Report to Planning and Environment Committee

Subject: Oxbury Centre Ltd. (c/o Westdell Development Corporation)
625 Mornington Avenue (1299 Oxford Street East)
File Number: Z-9589, Ward 4
Public Participation Meeting

Date: December 4, 2023

Figure 3 - Conceptual Site Plan (November 2023)

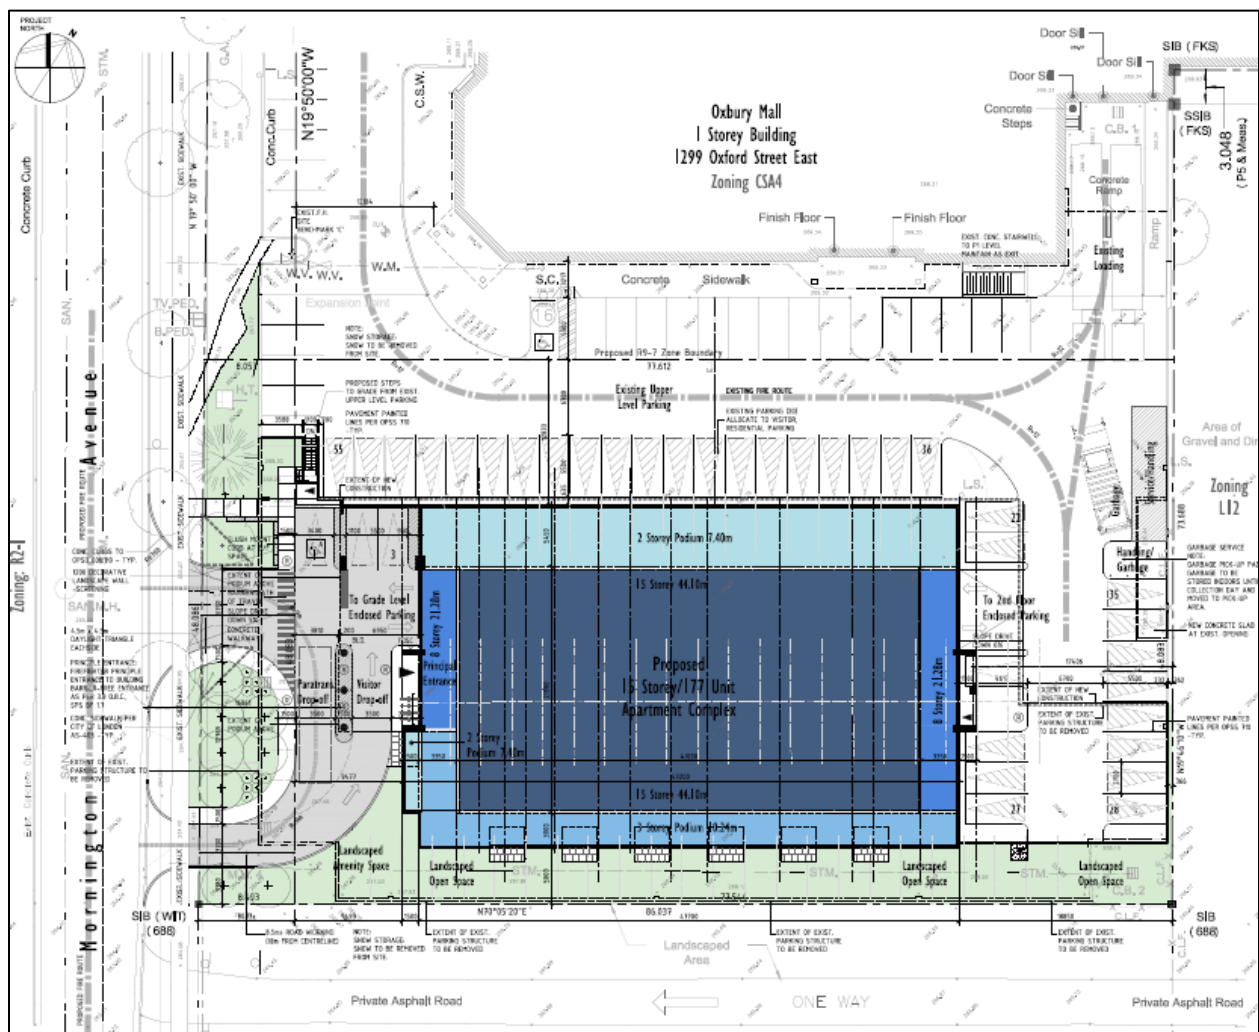
The applicant met with Planning and Development staff through the review of the application to address several form-based concerns and to provide for a design solution that justifies the proposed building height. The following is a summary of the changes made to the site and building design:

- Reduced height from 18 storeys to 15 storeys.
- Reduced apartment building GFA from 21,319 m² to 16,037 m².
- Reduced podium height from 4 storeys to 2 storeys on the north façade and 3 storeys at the south façade.

- Increased south side yard setback from 3.95 m to 5 m, plus an additional 3 m to tower.
- Increased setbacks at 4th to 7th floors.
- Reduced floorplate areas – less than 900m² at 8th floor and beyond.

- Removed all parking from south and southwest side and relocated to the north side of building.
- Significant south façade changes – replaced parking with dwelling units on the first 4 storeys; also provided increased glazing, patios, balconies and terraces on this side of the building.

Staff recommend the following additional special provisions to ensure conformity with the policy framework, to implement the revised proposal, and that serves to mitigate impacts of the proposed development on the existing surrounding residential neighbourhood:

- Minimum and maximum podium heights of 2 storeys and 3 storeys, respectively.
- Minimum front yard stepbacks of 3 metres above the 2nd, 3rd and 7th storeys.
- Minimum 55% glazing on the west (front) façade of the podium.
- Minimum 40% glazing on the west (front) and east (rear) façades of the tower.
- Minimum 45% on the north and south façades of the tower.
- Minimum ground floor height of 3.6m.
- Principal building entrance for the residential lobby along Morning Avenue.
- Maximum floorplate size of 1,000m² above the eighth storey.

Proposed Ground Floor Plan Floor Plate 1522.16m² (16384.93ft²)

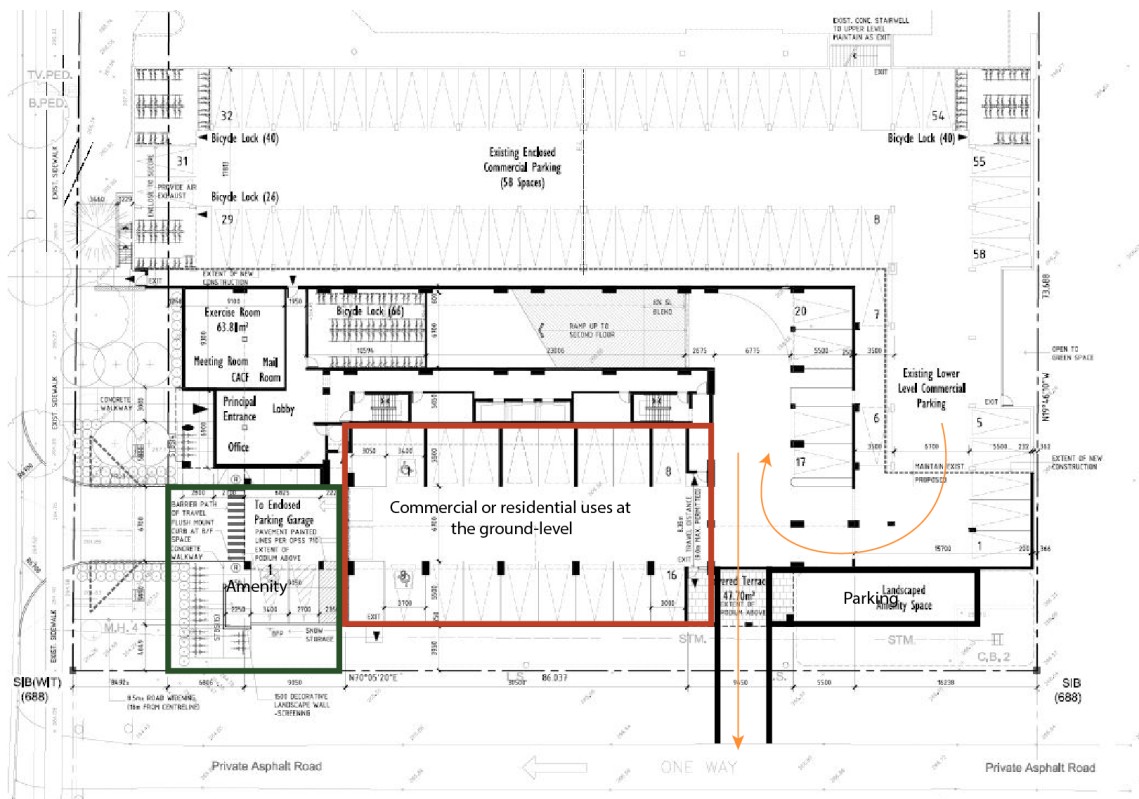
- Ensure that the elevations and renderings match the site plan. Ensure that the surrounding context is included in the elevations, site plans, and renderings. Provide a rooftop plan that outlines the placement and screening of any mechanical equipment. Further Urban Design comments may follow upon receipt.

- Clarify the location of the primary entrance along Mornington Avenue and provide signage to identify the main public lobby entrance.
- Clarify the condition between the proposed building and the existing parking structure along the northern elevation. Is the walkway enclosed or open-air? Ensure that the width of the walkway is a minimum of 2m.

- Consider providing an underground parking facility to reduce the height of the proposed built form. Refer to the London Plan, Policy 814.11.
- Consider removing the parking garage access from Mornington Avenue. Consider a joint access / access easement for the parking entrance from the private asphalt road (Canada Post) to the south or through the existing commercial parking garage.
